Access Compliance Report

Public Rights-of-Way

(Curb Ramps)

Intersection ID: 20593	Main Street: BROAD_OAK_DR	Cross Street: RED_HICKORY_LN	Location: NW
ADA ID: FAAA6EEA9466	Ramp Type: Directional1	Initial Pass/Fail: Fail	Overall Compliance: No
Severity Score: 12.5			
Codes/Mitigation Info/Possible Solution		Field Measurements/Component Compliance

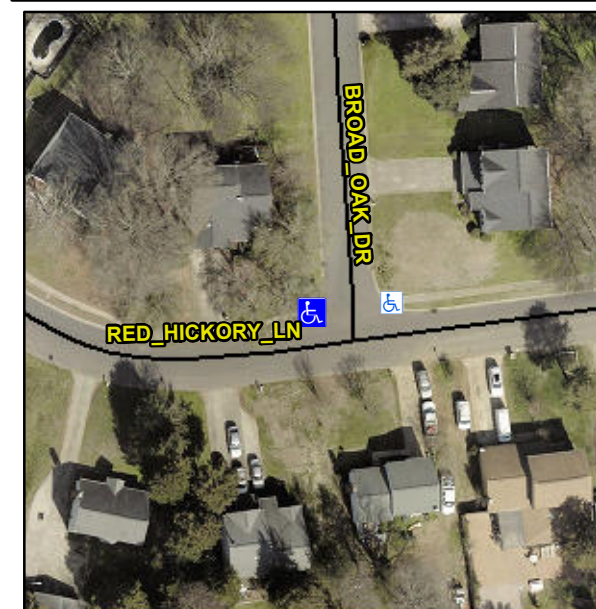
R304.5.3

Compliance	Description	Data	Compliance	Description	Data
N/A	Ramp Length (in)	49.0	N/A	Grade Break?	N/A
Yes	Ramp Width (in)	48.0	N/A	Grade Break Slope (%)	0.0
Yes	Ramp Slope (%)	6.9	N/A	Grade Break XSlope (%)	0.0
No	Ramp XSlope (%)	5.9			
N/A	Flare Type LT	N/A	N/A	Flare Type RT	N/A
N/A	Flare Slope LT (%)	N/A	N/A	Flare Slope RT (%)	0.0
N/A	Flare Traversable LT?	N/A	N/A	Flare Traversable RT?	N/A
N/A	Landing Length (in)	0.0	N/A	DWS Provided?	N/A
N/A	Landing Width (in)	0.0	N/A	DWS Contrast?	N/A
N/A	Landing Slope (%)	0.0	N/A	DWS Length (in)	N/A
N/A	Landing X Slope (%)	0.0	N/A	DWS Full Width?	N/A
N/A	Landing Curb? (Y/N)	N/A	N/A	DWS Offset LT (in)	N/A
N/A	Shared Landing?	N/A	N/A	DWS Offset RT (in)	N/A
N/A	Gutter Ponding?	0.0	N/A	Gutter Slope (%)	N/A
N/A	Gutter Lip Ht (in)	0.0	N/A	Gutter X Slope (%)	N/A
N/A	Painted X Walk1?	No		Road Slope (%)	0.5
	X Walk 1 Direction	To NE		Road X Slope (%)	2.2
	X Walk 1 Width (in)	N/A		Clear Space?	N/A

X Walk 1 Slope (%)	0.5	N/A	Clear Space to XWalk (in)	N/A
	X Walk 1 X Slope (%)	2.2	N/A	Storm Grate/Utility Hazard?	N/A
N/A	Ramp inside XWalk1?	N/A		Storm Grate/Utility Type	
N/A	Any Obstructions?	N/A			N/A
	Obstruction Type		Yes	Surface Condition? (G/P)	Good
			N/A	Curb Slope (%)	8.1

Remove & Replace Entire Ramp.
